Re: St. Lucie Plant Unit 1
Docket No. 50-335
Renewed Facility Operating License No. DPR-67

Response to NRC Reactor Systems Branch Request for Additional Information
Regarding Extended Power Uprate License Amendment Request

Response to Request for Additional Information

Figure 1: k-eff vs. H/X plot

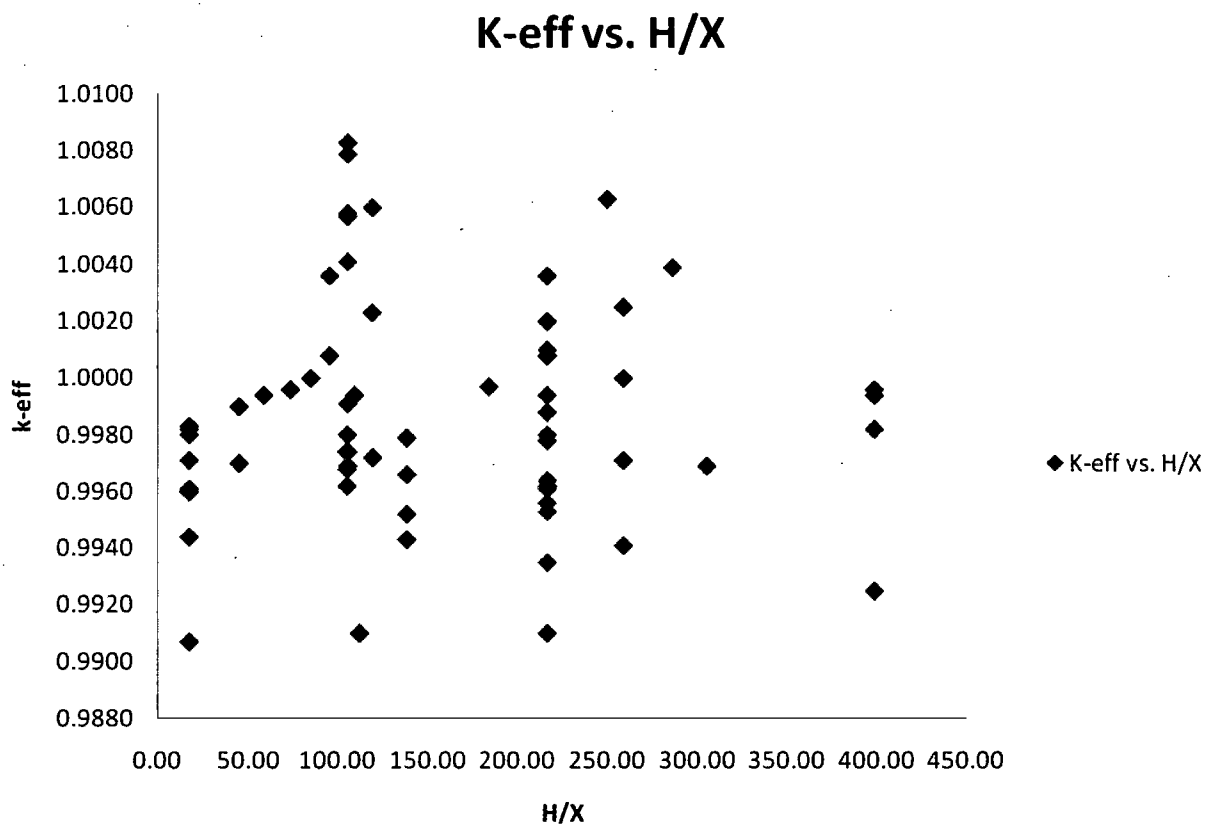
The optimum moderation case where the new fuel vault is subjected to low density moderation (e.g., fog or foam) was analyzed at 9 percent water density. Discuss and justify the applicability of the MCNP4a validation at these low density moderator conditions.

In response to the NRC RAI regarding benchmark calculations for optimum moderation case, MCNP4a benchmark calculations have been updated with 8 new experiments. These 8 new experiments represent the most densely packed module and consist of a 15x17 matrix of fuel pins (less four corner pins) loaded on a triangular pitch. This module is referred to as triangular or T type. This T type experimental configuration results in an H/X of 17.43, where H/X is the atom ratio of moderator to fuel. The H/X for the optimum moderation condition (9% water density) for the new fuel vault is 10.04. The following represents a description of the 8 new experiments.

In order to satisfy the normality assumption, Pearson's chi-square (χ^2) test [Reference 1] is employed on the set of 64 experiments. Additionally, linear trend analysis is performed to determine whether there is any linear relationship between the MCNP calculated k-effs and H/X. Based on the coefficient of determination ($R^2=1.75E-07$), it is determined that there is no significant linear relationship between calculated k-effs and H/X [Reference 1]. Figure 1 presents the distribution of the k-eff values versus the trending parameter, which in this case is the H/X. This plot also visually confirms that there is no significant linear trend. Since there is no trend, extrapolation outside the H/X range, especially to 10.04 from 17.43 for the new fuel vault, is acceptable and therefore the bias and bias uncertainty calculated above are applicable for the new fuel vault calculations. Additionally, NUREG/CR-6698 states that (in Section 5) 10 percent extrapolation from the validation data (H/X range used is 17.43-398.69) is permissible.

The max total k-eff is increased by ~41 pcm, which is rather insignificant. Note that for all the new fuel vault calculations, the steel rack structure is conservatively replaced by water in the MCNP model.
